STAFF REPORT: FEBRUARY 9, 2022 MEEETING

ADDRESS: 1535 LEVERETTE

APPLICATION NO: #22-7656

SCOPE: ERECT NEW ADDITION AT REAR; REHABILITATE DWELLING

1535 Leverette, current appearance, New vinyl-clad windows to be installed at these locations. Area outlined in red shows location of 1985 addition

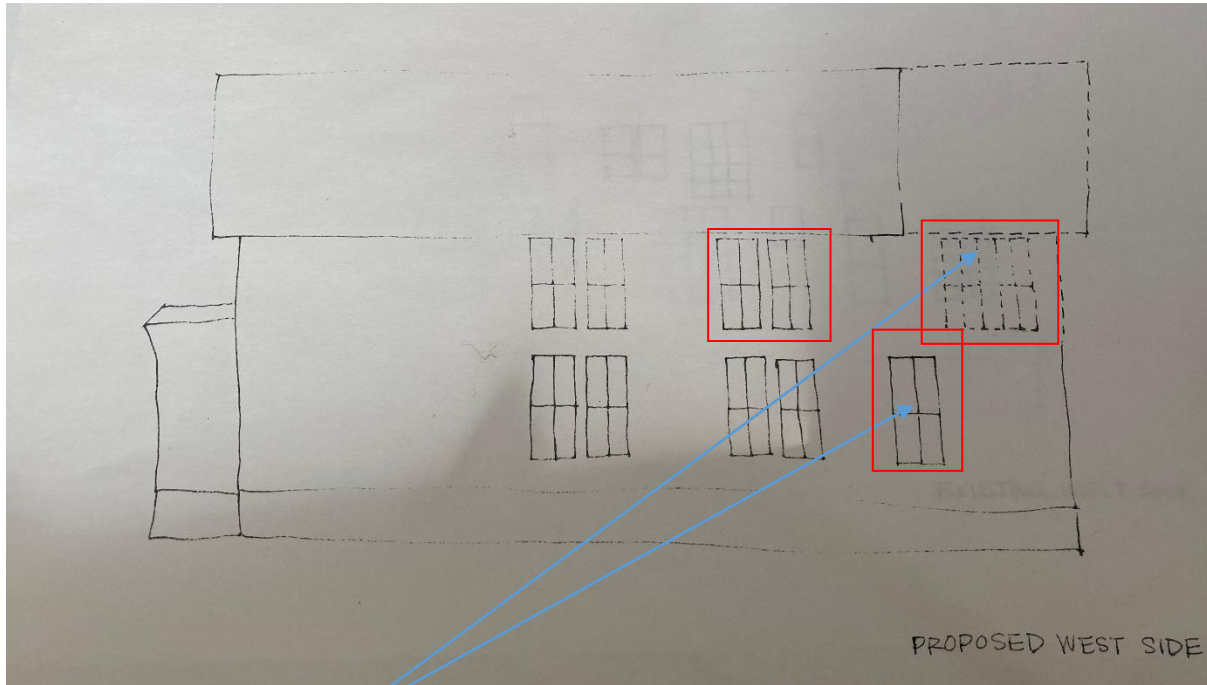
- Although the new windows proposed for installation at the west elevation are located towards the rear of the wall, in the portion of the building that was erected in 1985, they will be visible from the public right-of way. The single, rectangular casement at the first story appears to be of a regular/compatible scale/size and shape. However, it is staff's opinion that the orientation of the new window proposed for the second story is not compatible to the building's historic character. Staff recommends that the shape of this window match the new casement proposed for the first story.

- The new casement windows proposed for installation at the rear and side elevation are vinyl-clad wood units. The new casement windows at the rear elevation will not be visible from the public right-of-way. Also, the areas of the building where the new casement windows will be installed are not original to the building/historic fabric and the new windows will not replace existing historic windows. Note, however, that that staff has little experience with vinyl-clad wood windows in re: to how closely they replicate historic wood windows and/or their long-term fitness versus low-grade full-vinyl extruded window units, which have rarely gained the Commission's approval. The Anderson 400 cutsheet/product information material does not speak to the use of this product within the context of historic architecture/buildings and the project architect has noted that he did not know of any examples where this product has been used in an historic home rehab. Staff therefore cannot proffer a recommendation for this product due to its lack of a track record for use within historic districts. A late request for a sample of this product was made but is not expected to be made available for Commission review.

- The new wood wall cladding proposed for installation at the side and rear elevations shall match the dimensions of the exposure and profile of the wood siding which exists at the front elevation
- The shape of the new casement window proposed for the second story, west elevation, shall match the shape of the new casement window proposed for installation at the first story.
- The new windows proposed for installation at the front and side elevations should either be wood or wood with aluminum cladding. The new windows cannot be clad with vinyl.
